re: Heywood Interconnector Upgrade – AER information request

ATTACHMENT A

This attachment outlines ElectraNet and AEMO's responses to the submissions provided to the AER on ElectraNet's clause 5.16.6 determination request, including Frontier Economics' modelling accompanying the Macquarie Generation submission. The three major sections of this response align with the three submissions received by the AER.

Figure 9: Augmented system with 650 MW Export (with contingency of a South East Transformer)

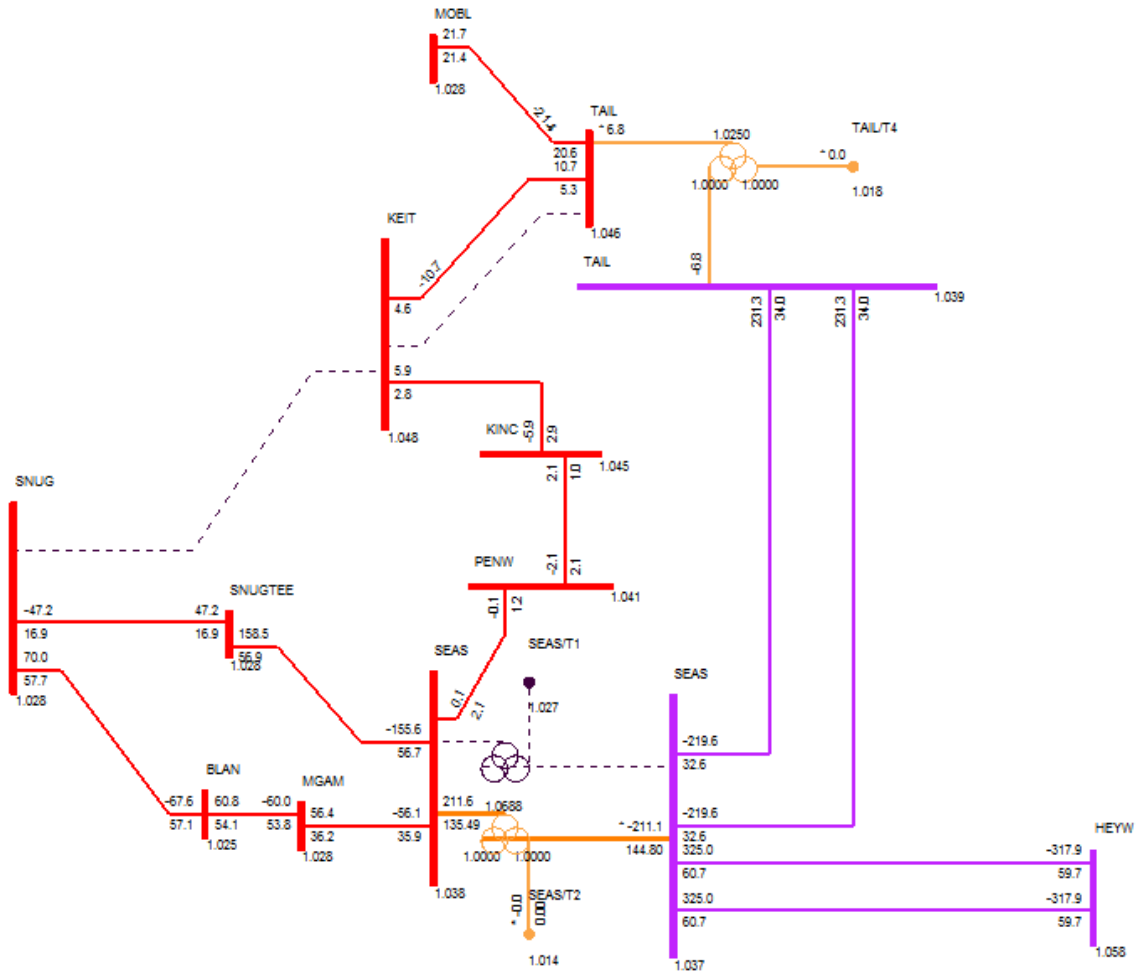
It may be noted that the remaining transformer remains overloaded, but the overload has reduced to 45%. The impact on generators will hence be reduced. Power flows on the 132 kV network from north to south are reduced after the proposed network augmentation, due to reduced impedance of the 275 kV network. The reduced impedance is from series compensation partially offset by the removal of one of the two 132 kV parallel paths.
